Barco service bulletin

Serial Number: 959
Date: 17/02/2011
Product: Lamp strike issues on DP2K-xxB series
Priority code*: C

1. LAMP STRIKE ISSUES ON DP2K-XXB SERIES

Image 2-4

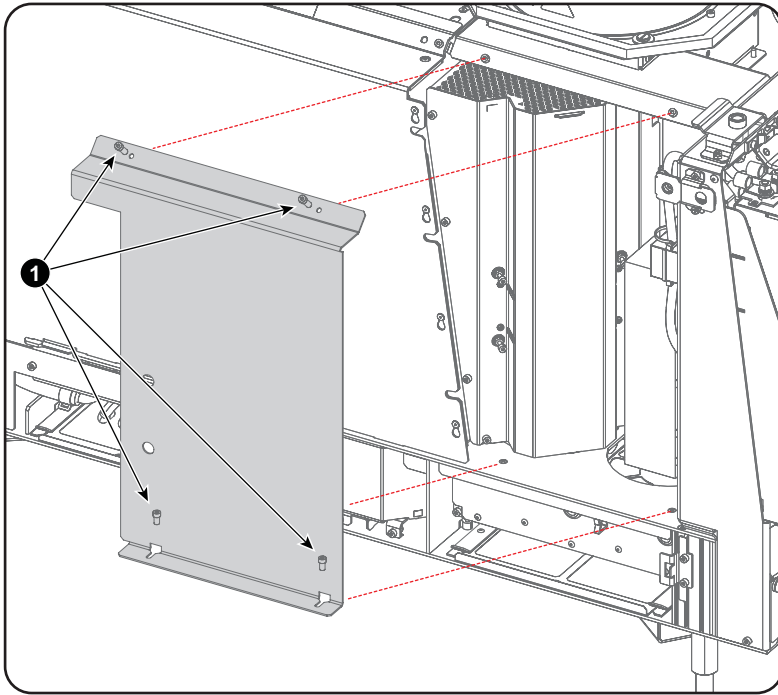
The cover plate of the SPG inside the projector has an effect on the magnetic field created by the coil in the SPG (start puls generator). This causes a loss of energy that result in a lower ignition voltage.

1. Remove the inner cover plate of the SPG/Cold Mirror compartment. Use a 3mm Allen wrench to release the four hexagon socket head cap screws (reference 1) as illustrated and take off the cover.

By removing the inner cover plate you can increase the ignition voltage. This results directly in an easier lamp strike.
